GENERAL ELECTRIC 807E152TY  
 FILE ELEM DIAG  
 NUC STEAM SUPPLY SHUTOFF SYSTEM  
 FIRST MADE 1968

STATUS DATE: 04-17-87  
 ADDITIONAL MARK LIP  
 PER FDDR KGI-5915-4,5

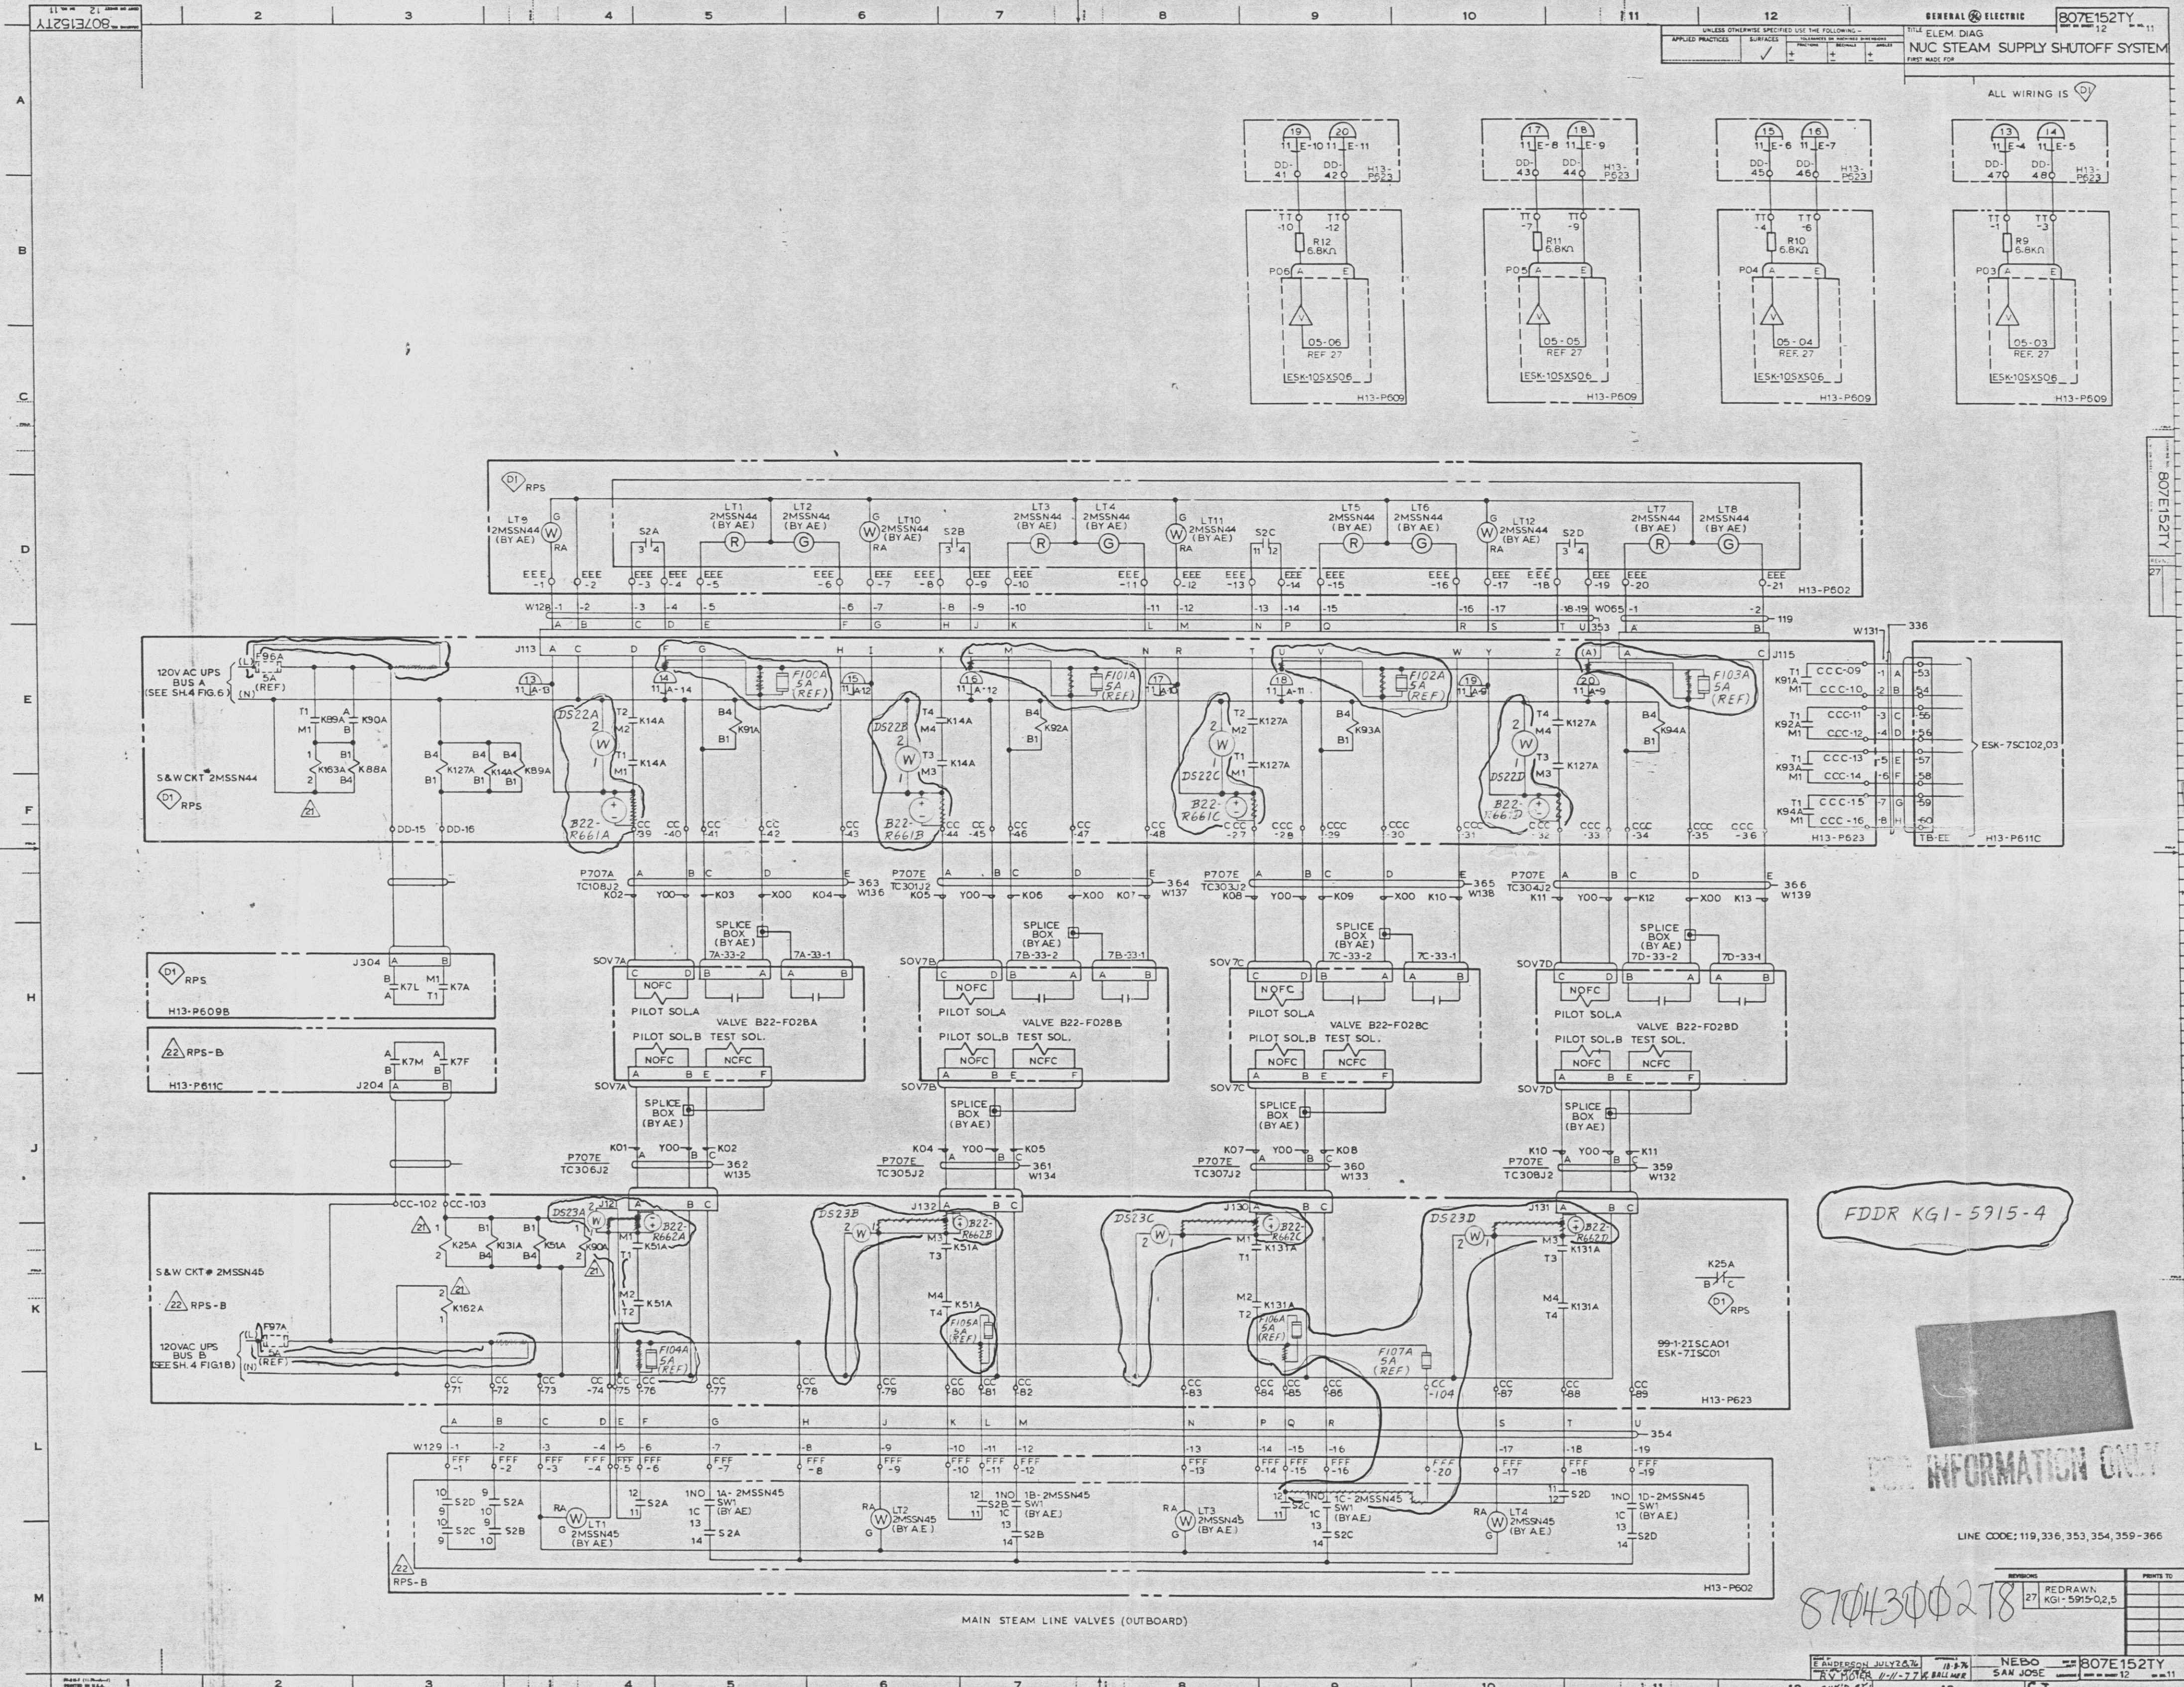
FDDR KGI-5915-4
